Subject: FW: 55 Vastern Road, Reading (200188)

Subject: 55 Vastern Road, Reading (200188)

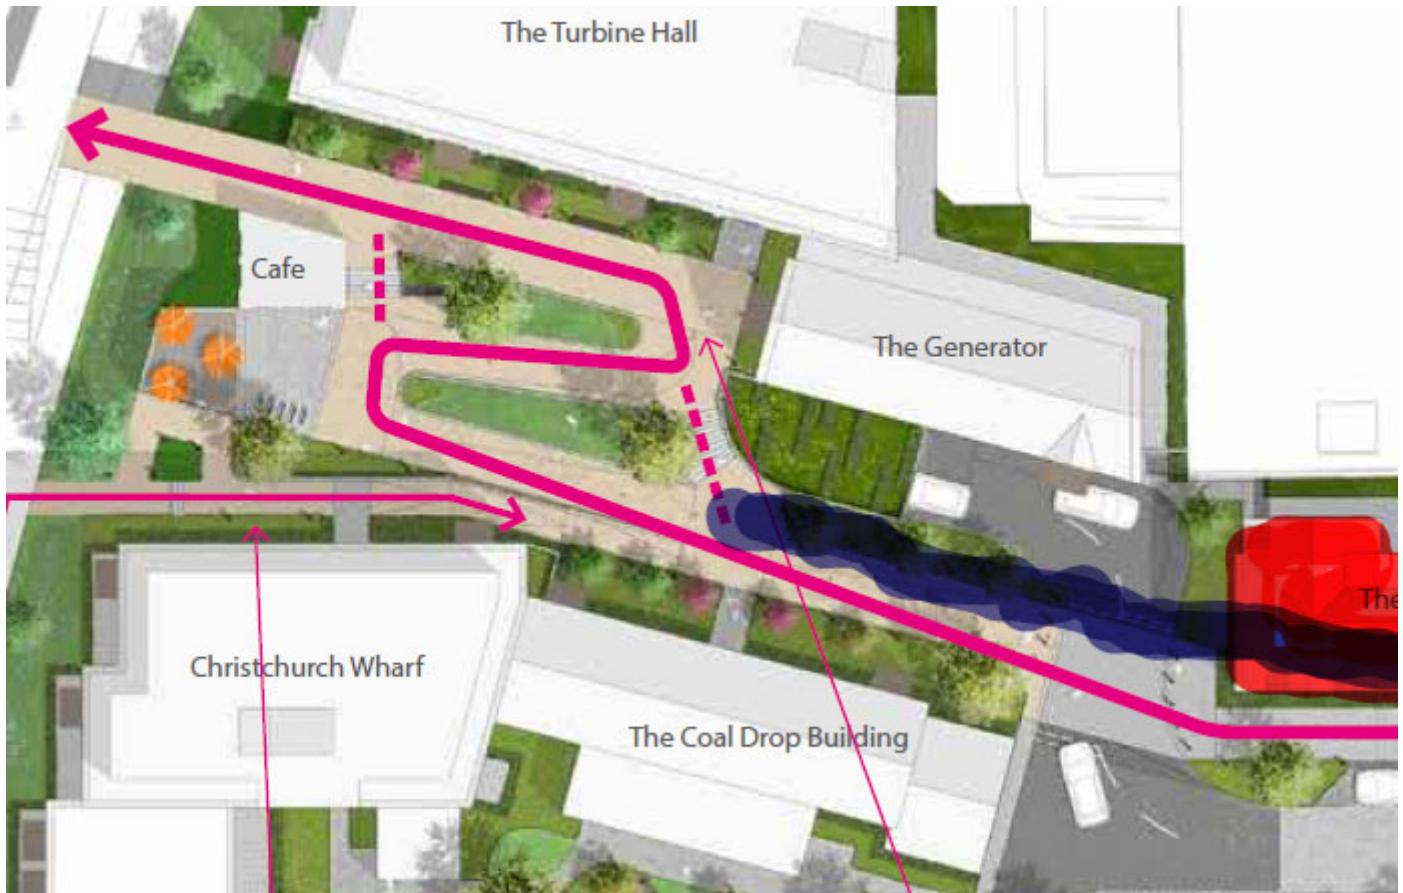
Further to our meeting last week, please see below what officers consider to be our preferred single north-south route through your application site.

As means of context, the areas in red are those where officers consider that the footprint of the buildings should be reduced/removed (i.e. the vast majority of the Goods Office and also the western tip of the Goods Warehouse, to enable the route to move slightly east, thereby making it more direct and optimising visual connections through to the river/bridge). To offset the reduction at the western tip of the Goods Warehouse, it is considered that you could explore reconfiguring this on the eastern side of the element which fronts the north-south route (marked by a green line).

The preferred single route is shown by the navy blue route which deviates from the existing route at the southern end of the site, before returning onto the current route (whilst maintaining the switchbacks is not ideal from the perspective of officers, it is considered in overall terms that this route signifies the best possible with all competing demands considered).

Officers consider that the middle element of the site (presently the Goods Office) could/should be utilised for public realm / public square / landscaping / public art and an acoustic barrier potentially also incorporating landscaping / public art, with natural surveillance provided from the northern elevation of the reconfigured Goods Warehouse.

My transport colleague advises that moving the route slightly to the east also allows for the disabled bays to be relocated adjacent to the route (given the increased space) and therefore this negates the need for the crossing facilities to be provided as per my transport colleagues previous requests.

Officers would encourage you to give this alternative route option serious consideration and ask that you agree to amend the route as requested.
